Change Order

PROJECT: *(Name and address)*
 Williamson County
 Animal Shelter Expansion
 1855 SE Inner Loop
 Georgetown, TX 78626

CHANGE ORDER INFORMATION:
 Change Order Number: 013

Change Order No. 13 includes the below listed Vaughn Change Proposals #47, 59-60. For Vaughn Project No. 2491-01.

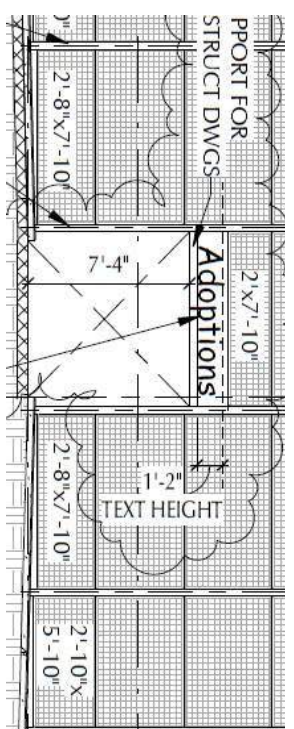
DESCRIPTION	SIZE	QTY	UNIT COST	EXTENDED TOTAL	NOTES
CHANGE ORDER BUDGET					
ADD LETTERS ON CANOPY: Line Length = 66"					
ADOPTION	14" h x 1" d	8	\$ 344.61	\$ 2,756.88	FCO Aluminum, baked enamel finish
Flat Cut Aluminum, Rail Mounted					bottom rail mounted to square tube on canopy provided by others.
Installation		1	\$ 1,275.00	\$ 1,275.00	
				\$ 4,031.88	TOTAL ESTIMATE

Dot will be attached with painted silver tab attached at the back of the letter.

Bottoms of letters will lap over the angle as shown (and as with the main building ID letters)
